SUBJECT: DAVIS-BESSE NUCLEAR POWER STATION, UNIT 1 – STAFF ASSESSMENT  
OF RESPONSE TO 10 CFR 50.54(f) INFORMATION REQUEST – FLOOD-  
CAUSING MECHANISM REEVALUATION (CAC NO. MF3721)

STAFF ASSESSMENT BY THE OFFICE OF NUCLEAR REACTOR REGULATION

RELATED TO FLOODING HAZARD REEVALUATION REPORT

DAVIS-BESSE NUCLEAR POWER STATION, UNIT 1

**Figure 3.2-1. Davis-Besse topographic elevations depicted in the LIP computer model prepared using FLO-2D Pro (as revised). Elevations reported are NAVD88.**

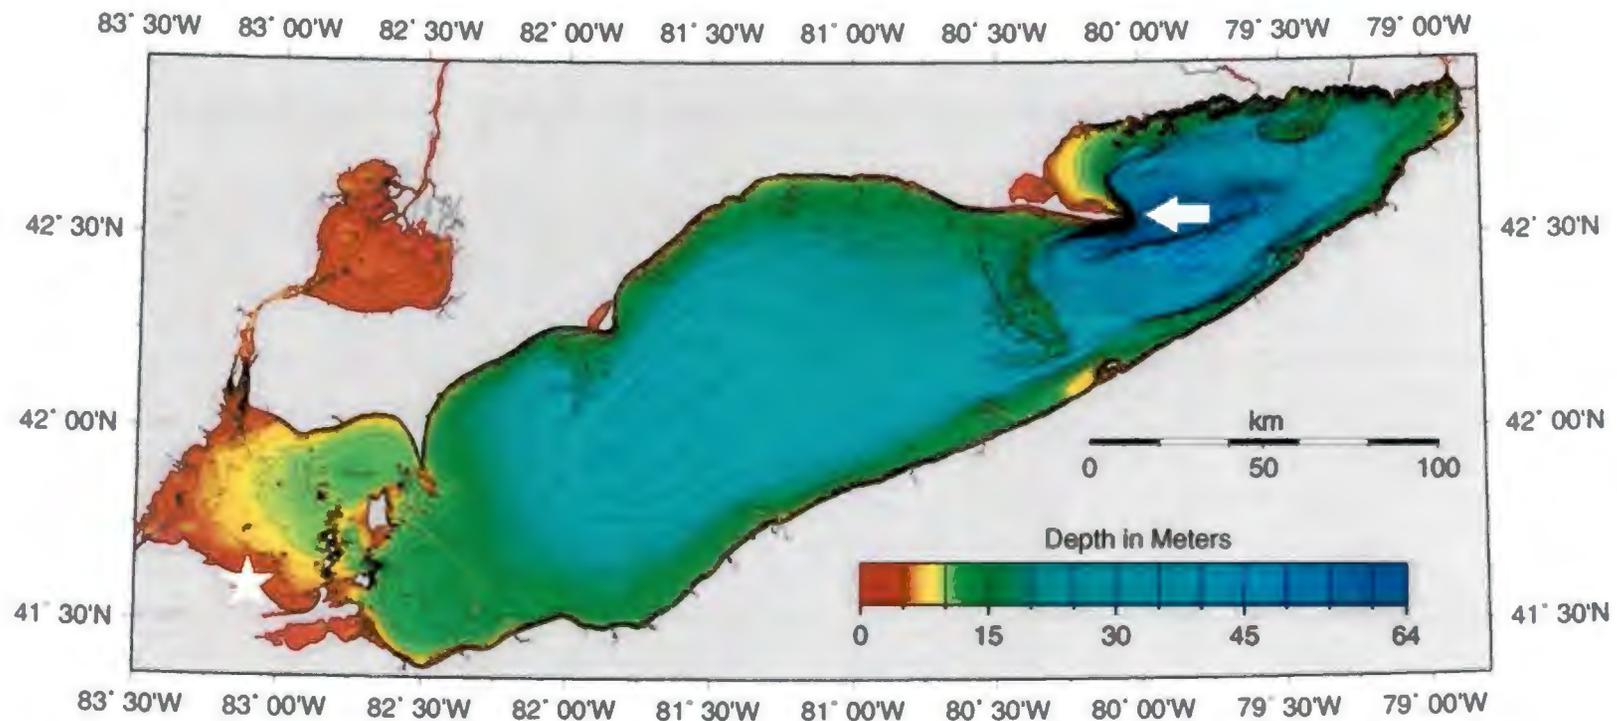
The licensee reevaluated the flood hazard resulting from LIP due to a thunderstorm over an immediate drainage area of about 0.3 mi<sup>2</sup> (0.8 km<sup>2</sup>) that included the footprint of the Davis-Besse powerblock, the site's vehicle barrier system (VBS), and all contiguous natural drainage areas in the 1.49 mi<sup>2</sup> (3.86 km<sup>2</sup>) controlled area. The licensee reevaluated the flood hazard due to LIP using a digital terrain model (DTM) to approximate the topographic ground surface corresponding to the reactor site and environs. Because the finished grade of the powerblock is elevated relative to the surrounding topography, the licensee generally did not include lower-elevation areas in its computational model as meteoric water would be expected to drain off-site via gravity as suggested by the results of the computer simulation shown on Figure 3.2-1.

The staff reviewed the licensee's approach to the development of the computation grid for the FLO-2D model against relevant regulatory criteria based on present day methodologies and regulatory guidance. The staff considers that the approach described by the licensee is reasonable.
